City of Milton

ITB 2020.01 Hamilton Bridge – Upgrade of water Distribution

ADDENDUM #2 -

March 6, 2020

1 WATER MAIN PLAN
C302 1" = 30'

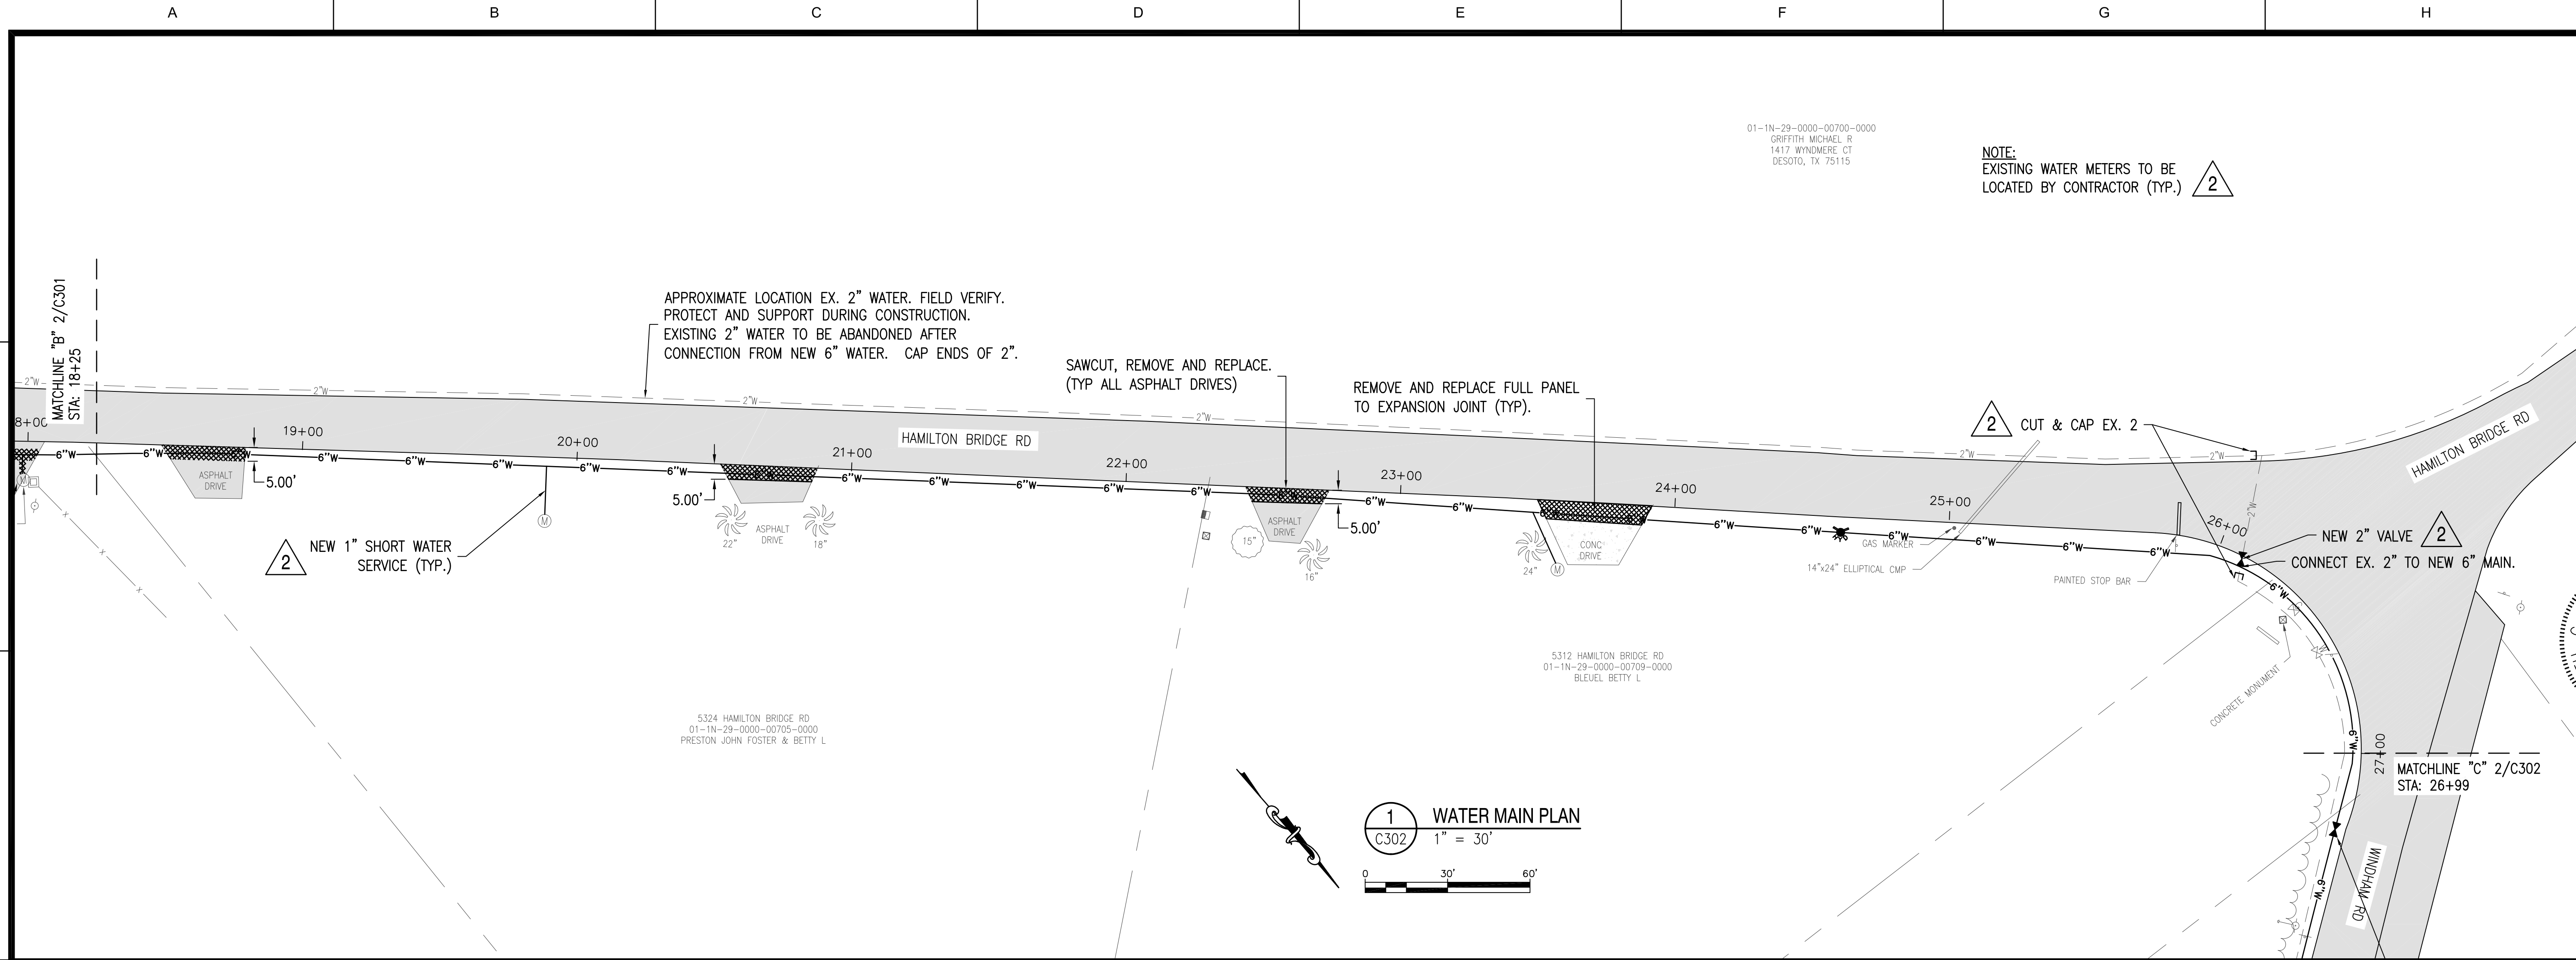
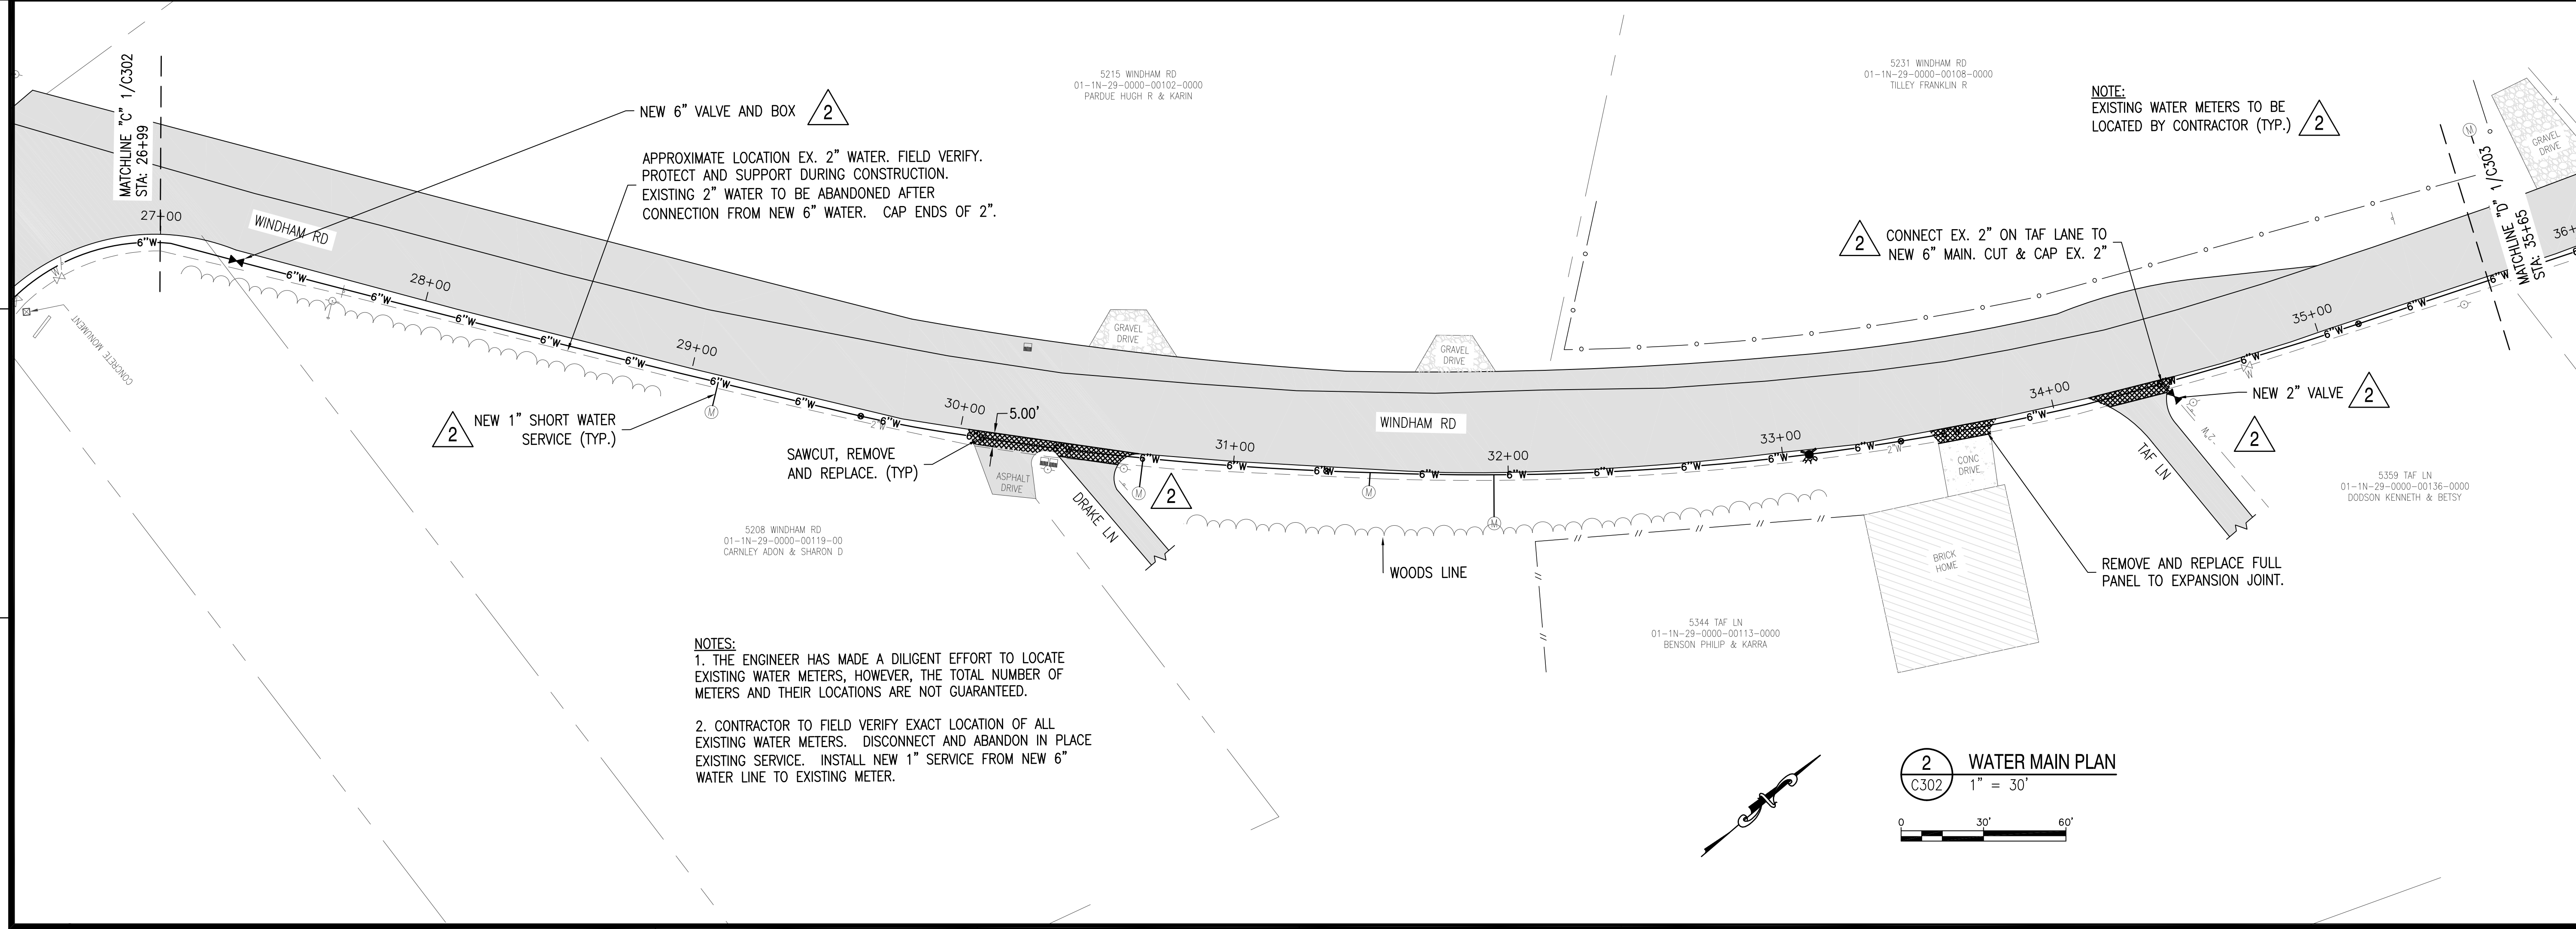
All water services to be 1 inch.

Change directional bores parallel to road, from 6" PVC to 8" HDPE, SDR 9. Connect with HDPE MJ Adapter and Sleeve.

Change directional bores across road from 6" PVC to 3" HDPE, SDR 9. Connect with MJ Adapter and Sleeve.

3. There appear to be nine 6" water crossings on sheets 302 and 303. What do we do here? Terminate at the R.O.W. with a cap? On page 301, the same symbol is calling for it to be a 1" service. Maybe they are all 1" water services?

4. The plans show multiple 6" Water laterals, crossing Windham Rd and Hamilton Bridge Rd. These are not shown as bores, they aren't quantified in the 6" Water pay item. How should this be handled?

Plans have been revised to reflect that the 6" water crossings are 1" water services.

Plans have been revised to reflect that the 6" water crossings are 1" water services.

F FDEP SEPARATION REQUIREMENTS
C501 N.T.S.

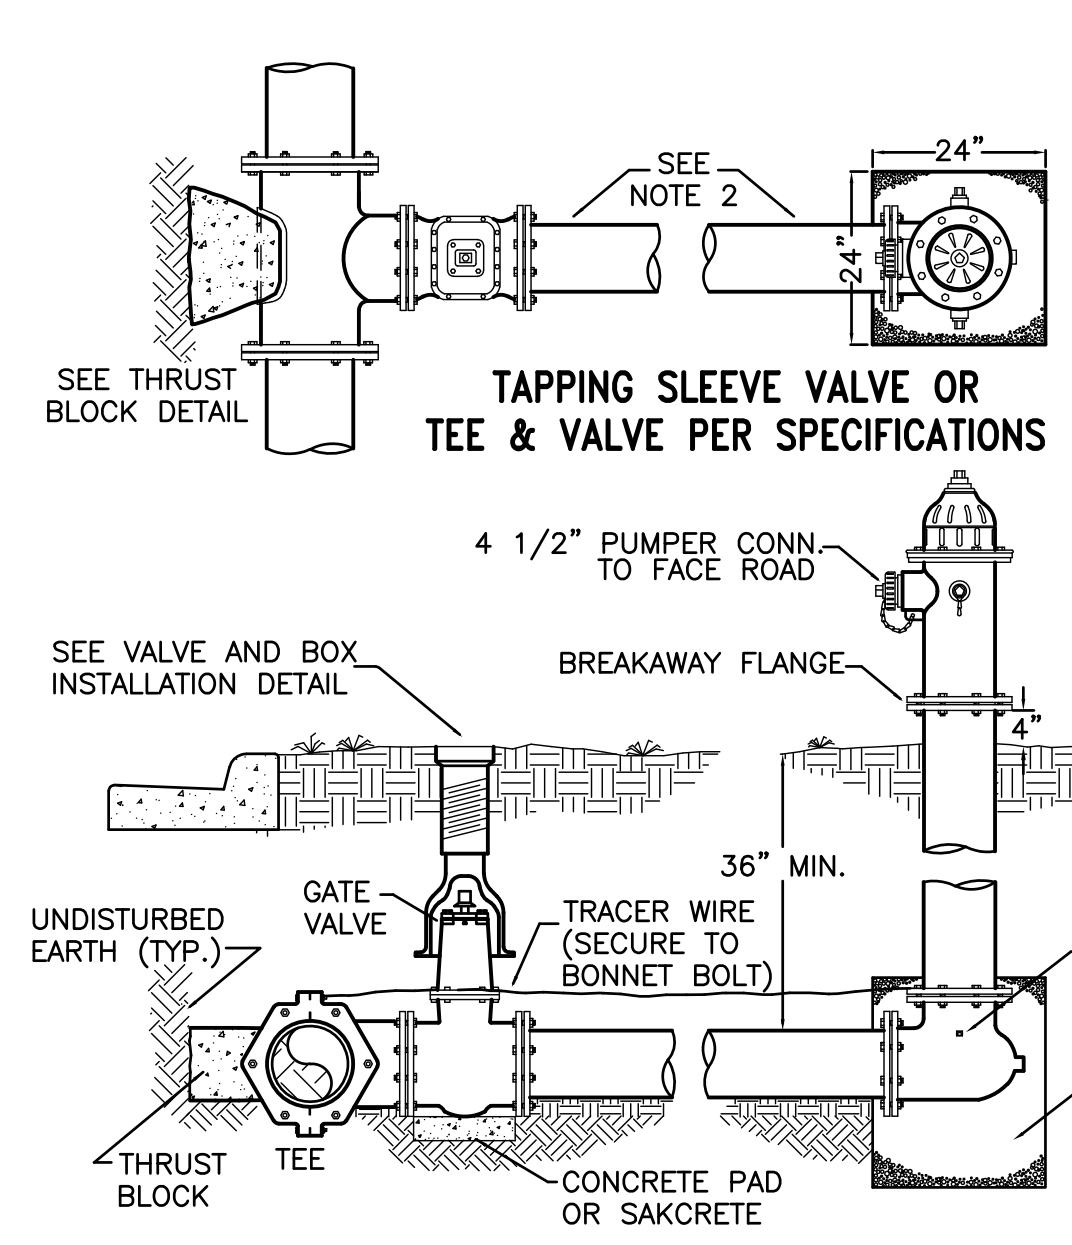
1. Removed water/sewer separation detail and replaced with FDEP separation detail.

A TYPICAL FIRE HYDRANT INSTALLATION DETAIL
C502 N.T.S.

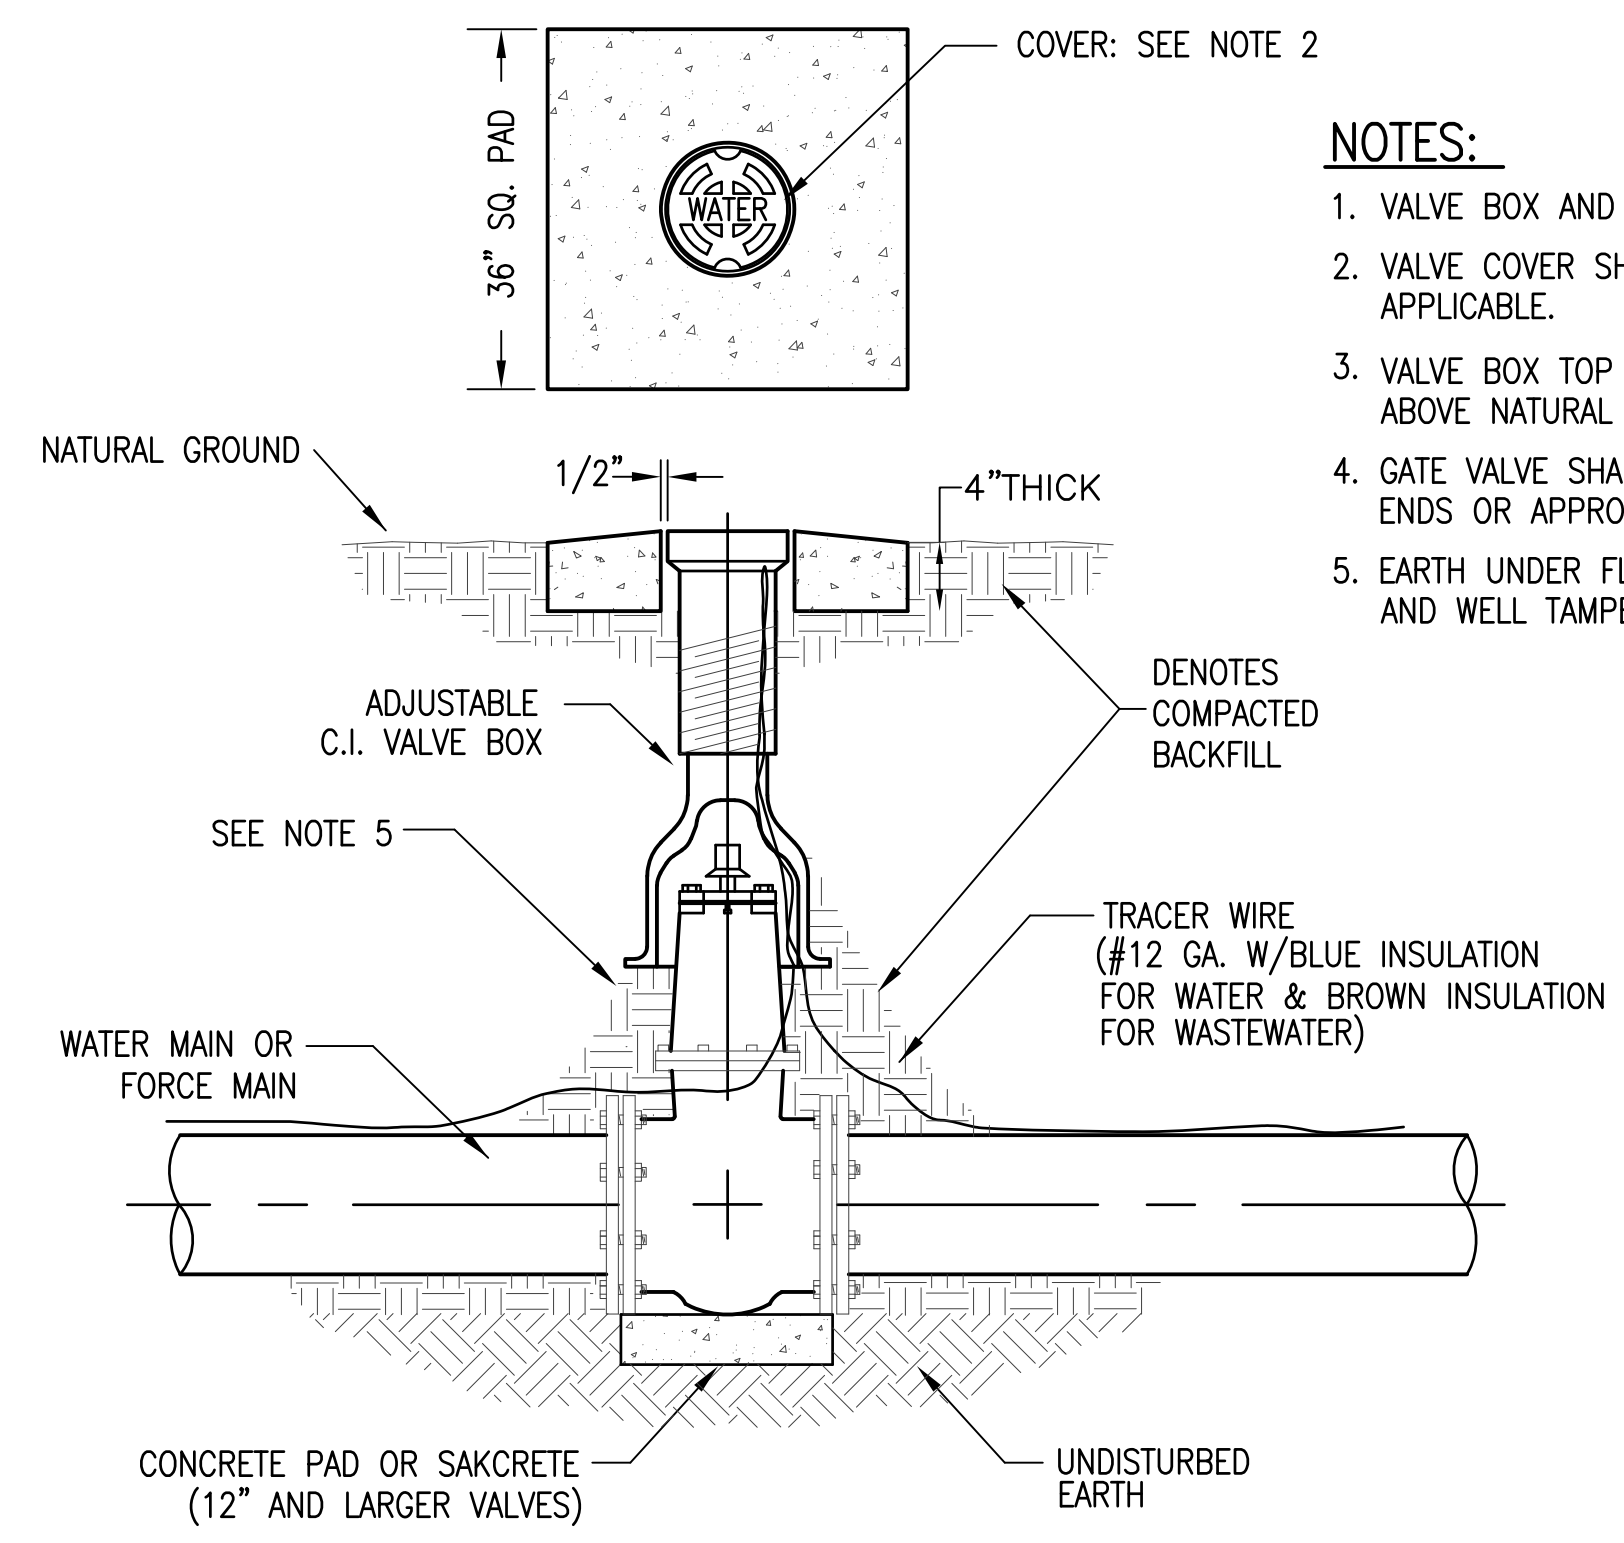
2. New fire hydrant detail.

6. On Sheet 502, there is a note on the fire hydrants. It calls for a flow test to be performed, and the bonnet to be color coded per the results of the flow test. Will the owner or contractor be responsible for performing the flow test?

The Fire Hydrant Detail has been revised on the Addendum No. 2 Plans. No flow test is required.
